DRAINAGE SUMMARY

PROJECT: MAUNALOA HIGHWAY, REPLACEMENT OF CULVERTS BETWEEN
MAUNALOA VILLAGE AND KAUNAKAKAI - PHASE II
PROJECT NO. RS-0460(3)

STATE OF HAWAII
DEPARTMENT OF TRANSPORTATION
HIGHWAYS DIVISION

Replacement of Culverts bet. Maunaloa
Village and Kaunakakai - Phase II

DETAILS OF 36" CULVERT @ ± STA. 93+20

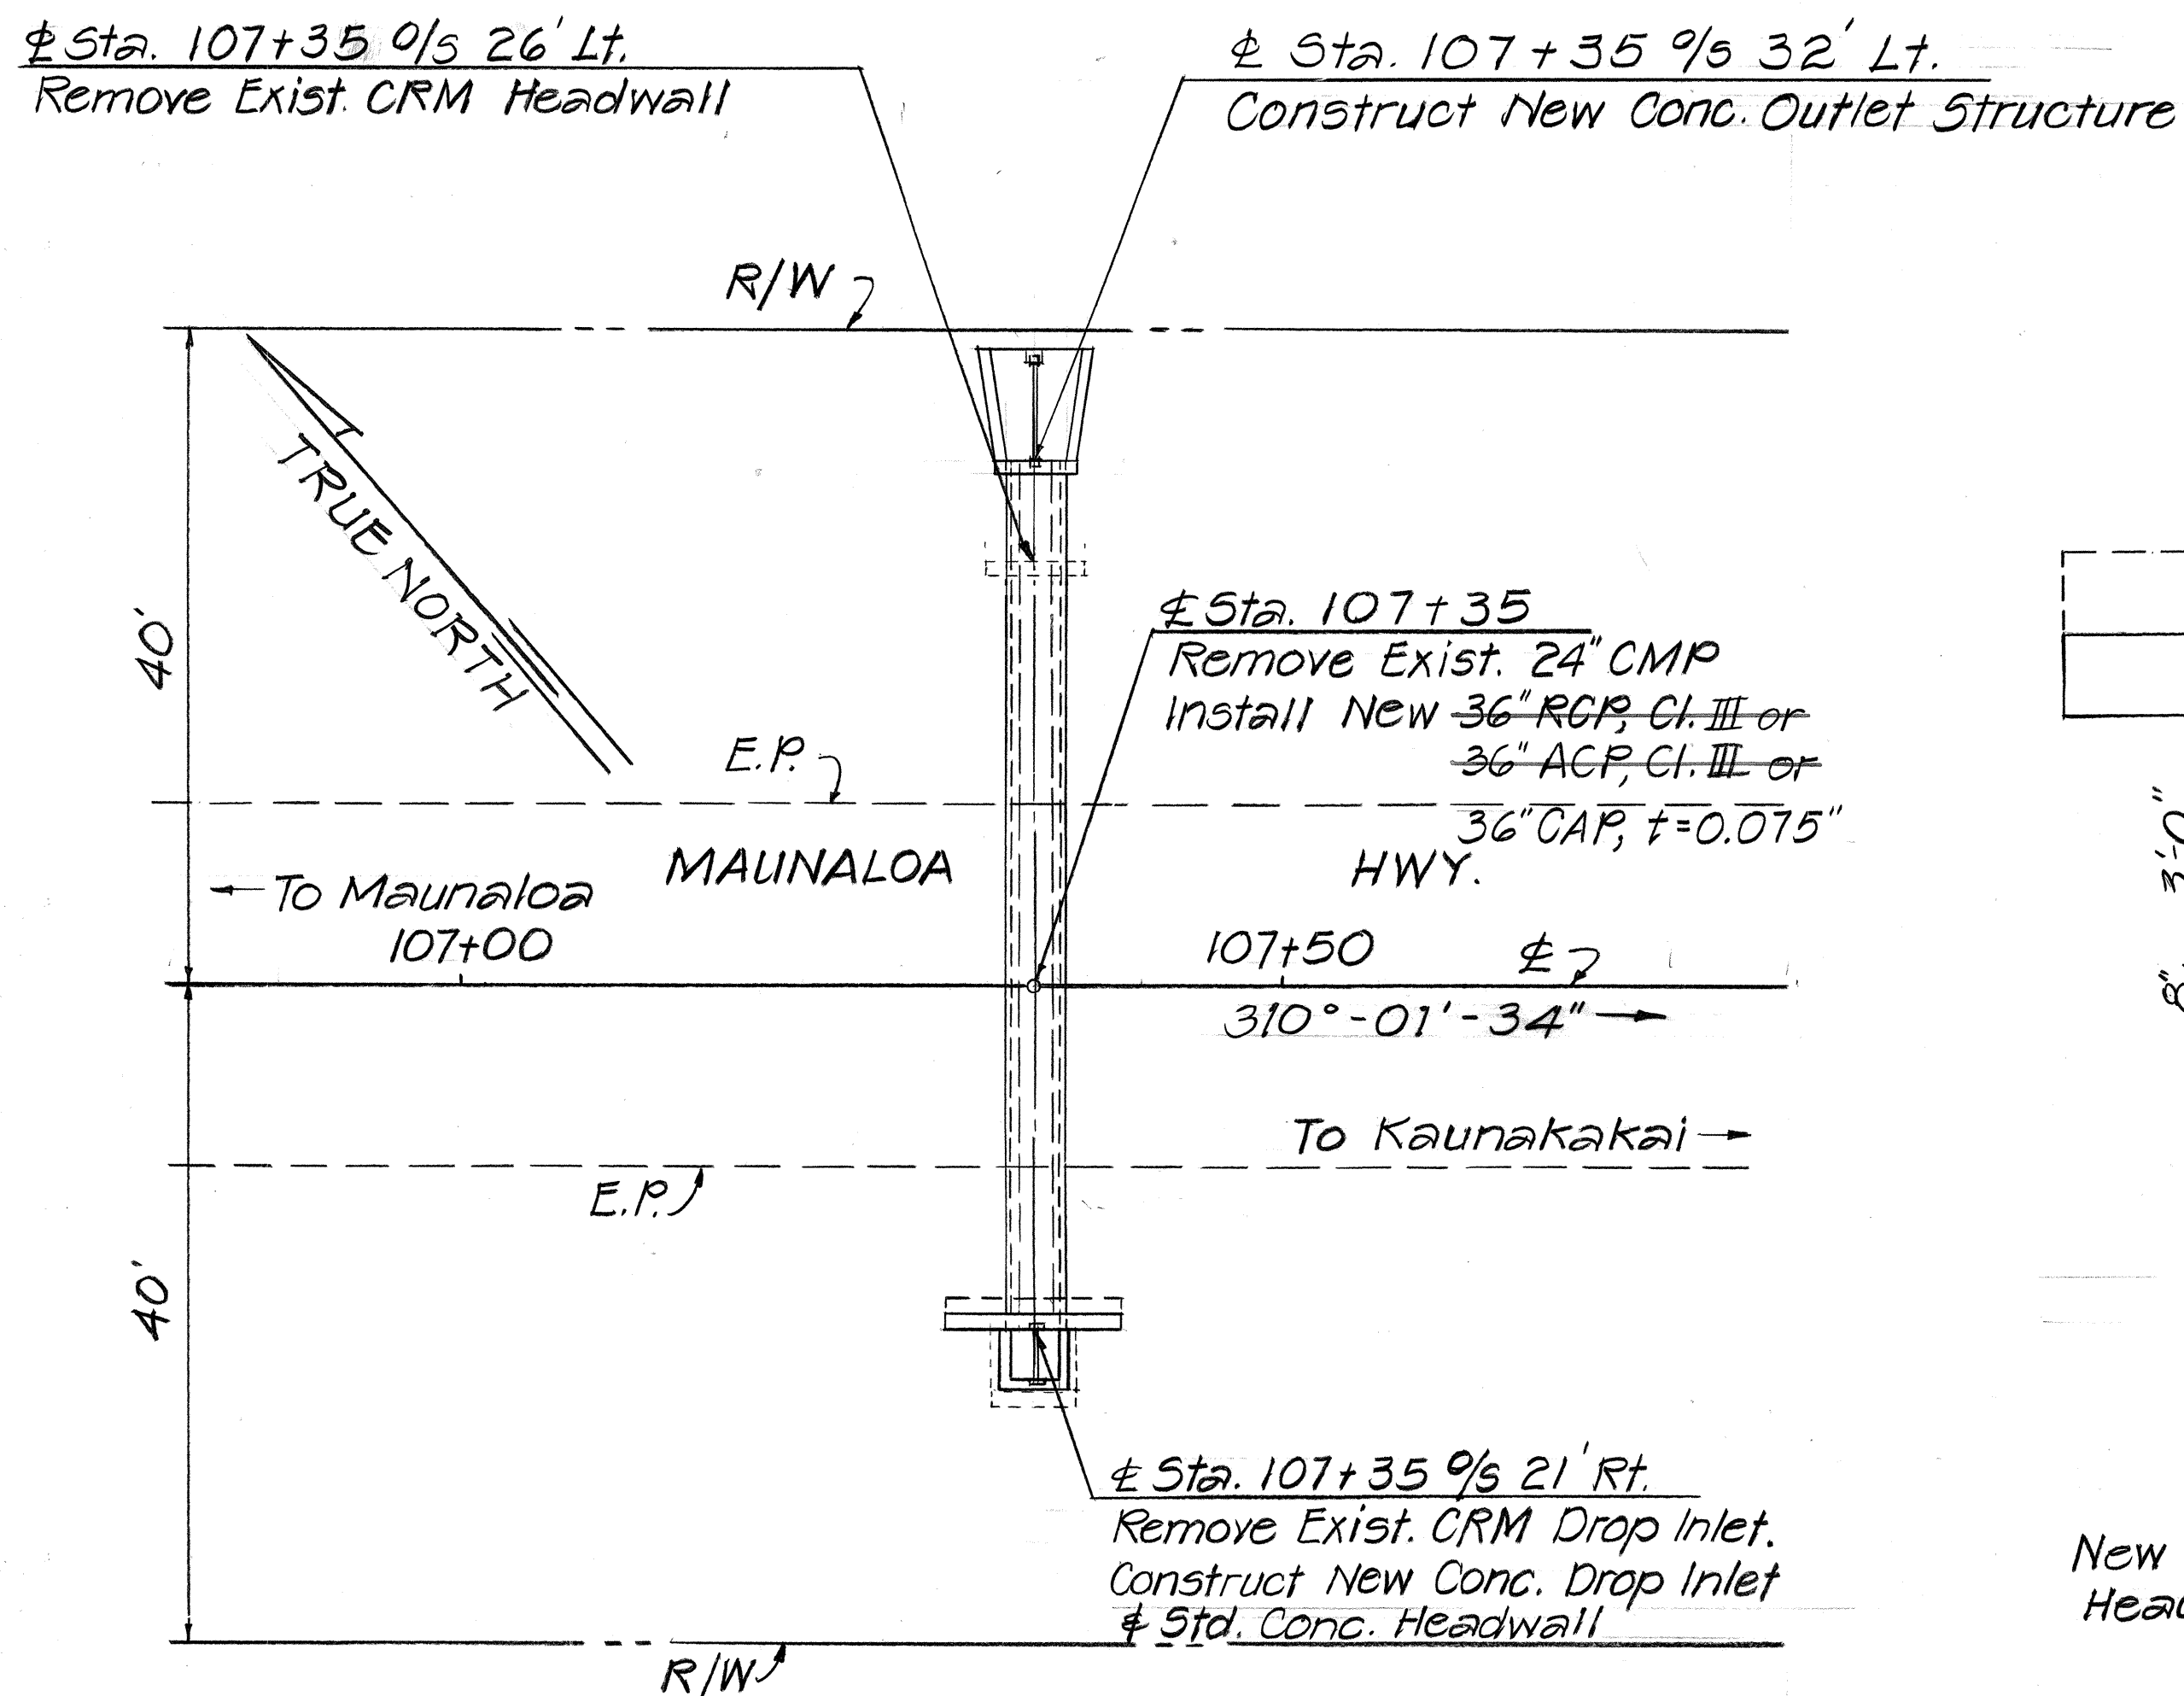
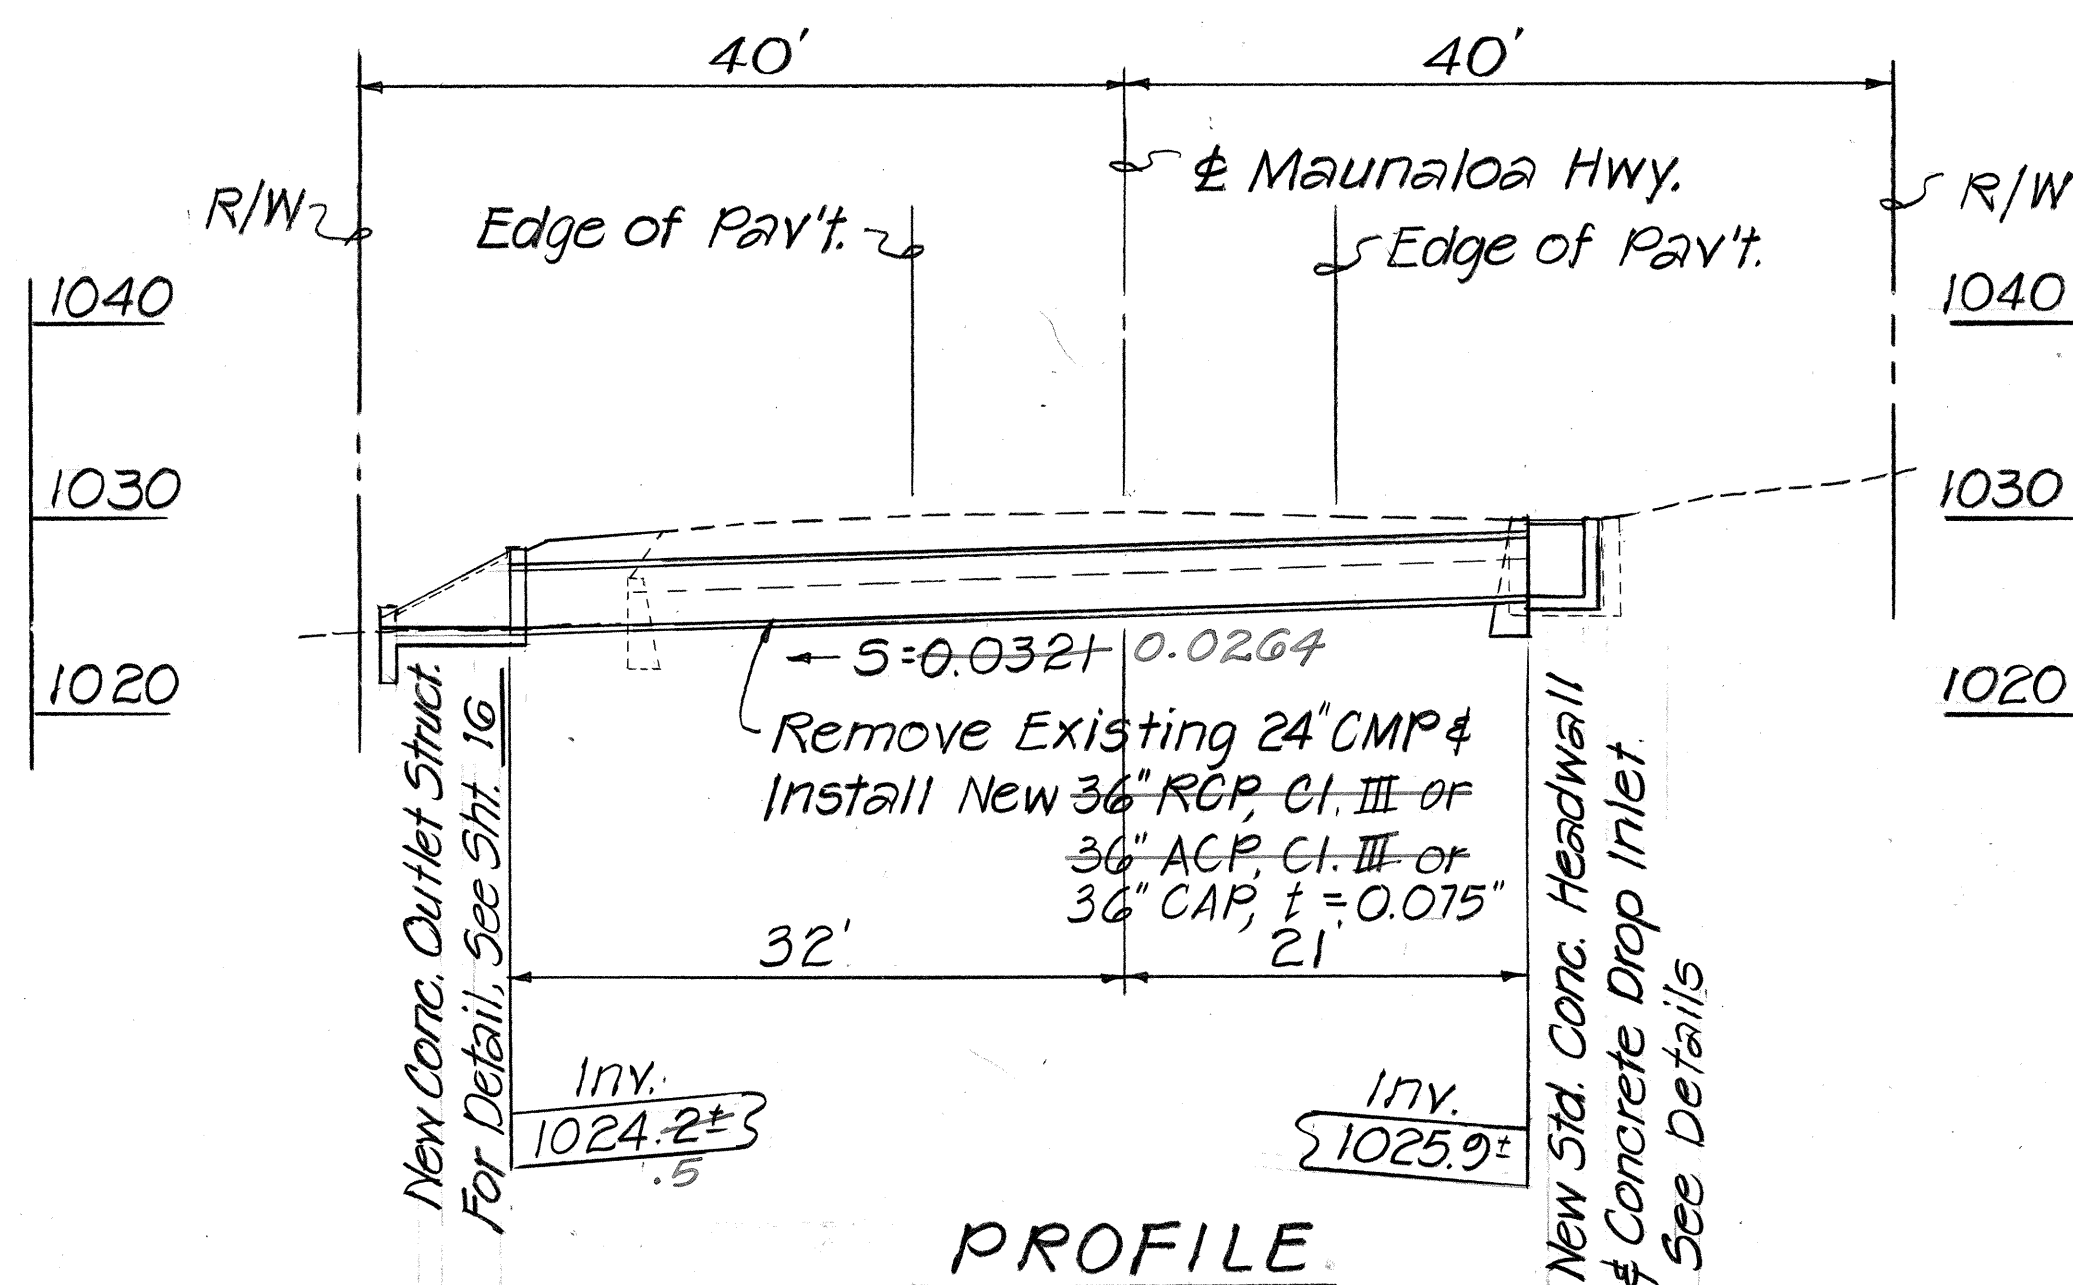
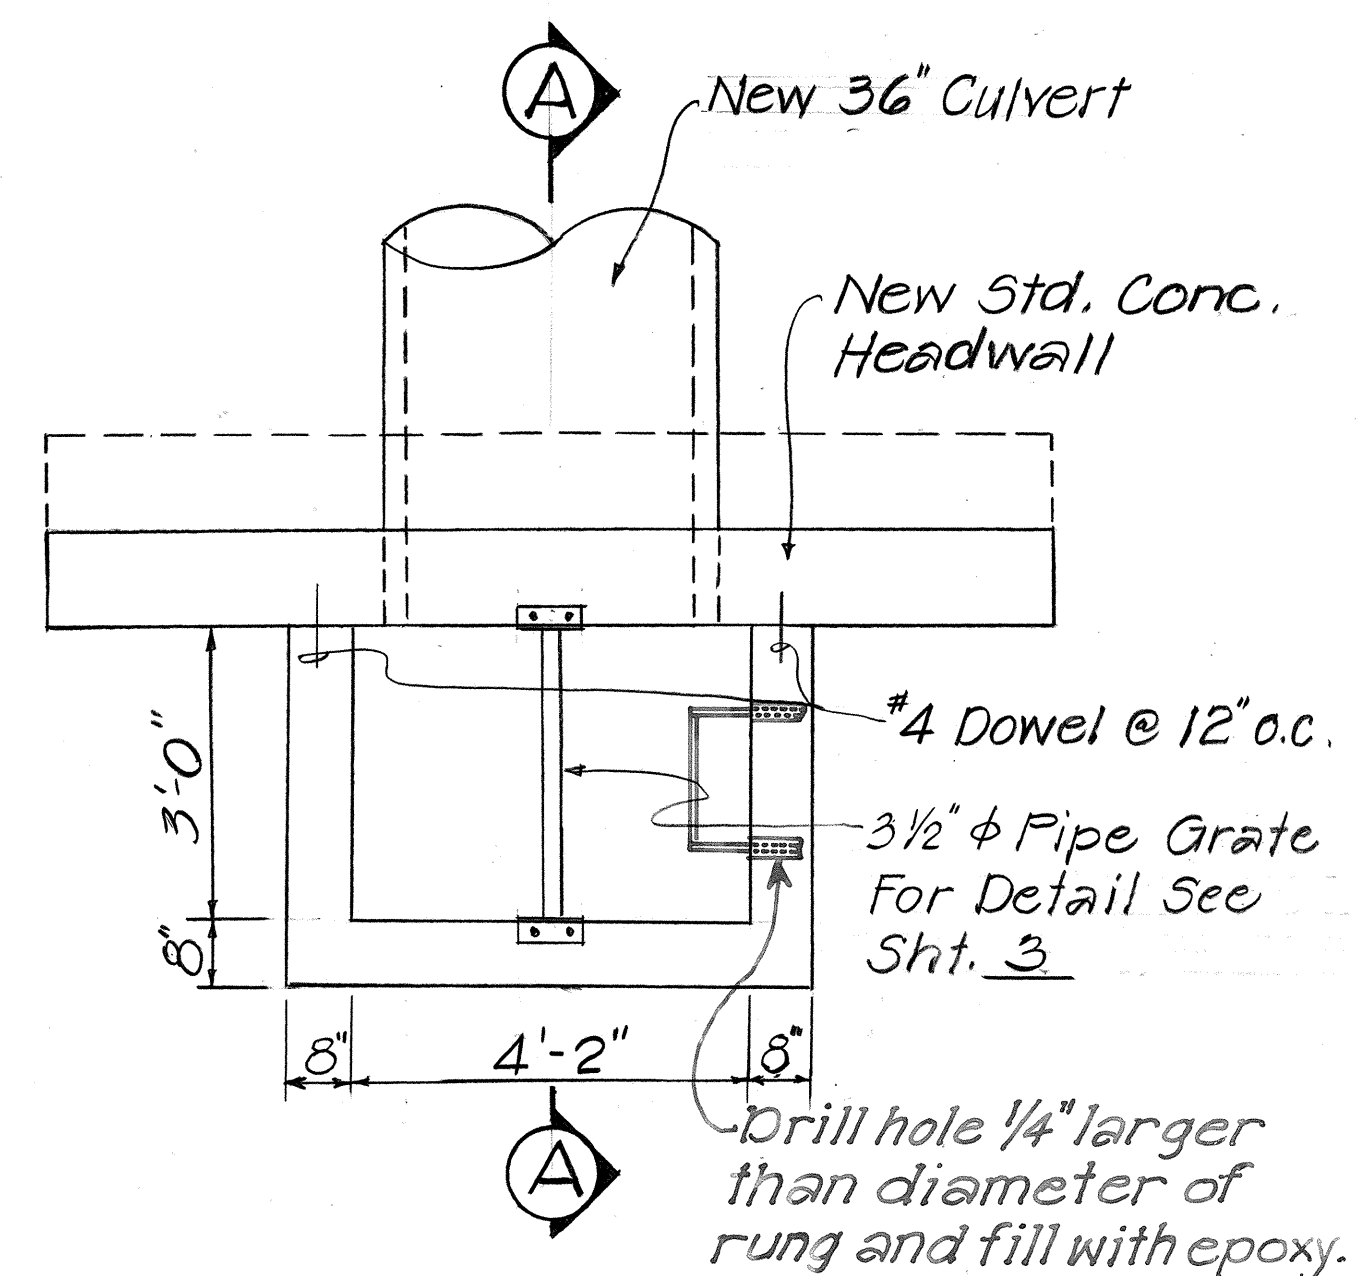
10/23/84 Per Addendum No. 1
Changed 42" CAP, t=0.105" to 42" CAP, t=0.075" (3x1)
